Date of Issue: July 2011

Affected Publication: API Standard 610, *Centrifugal Pumps for Petroleum, Petrochemical and Natural Gas Industries*, Eleventh Edition, September 2010

ERRATA

This errata corrects editorial errors in the eleventh edition of API Standard 610.

Figure C.1 — Typical HPRT arrangements

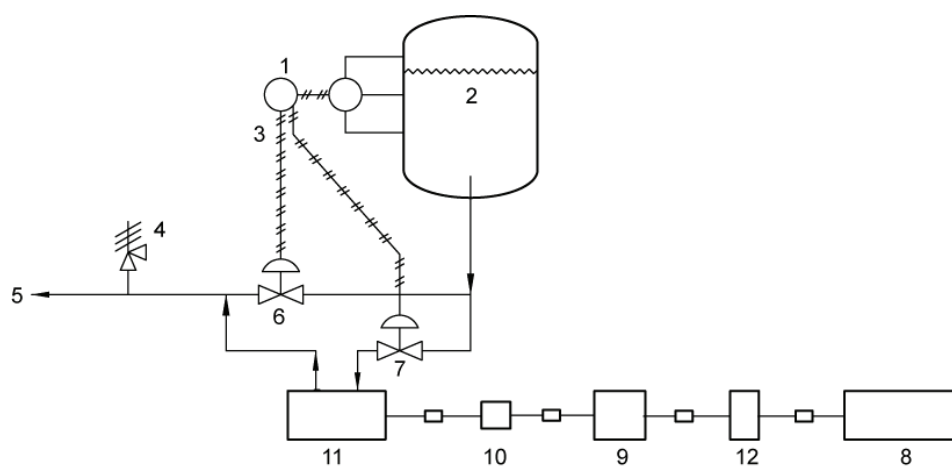
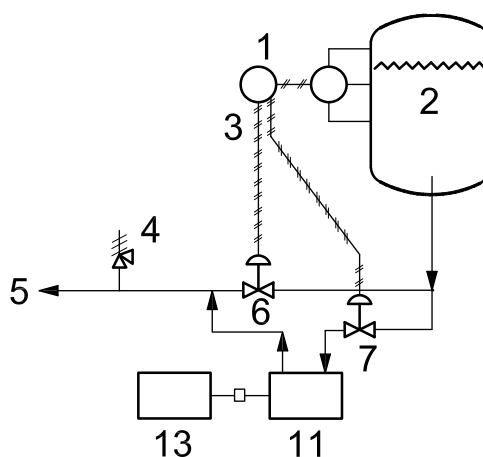
*Replace **Figure C.1** with the attached.*
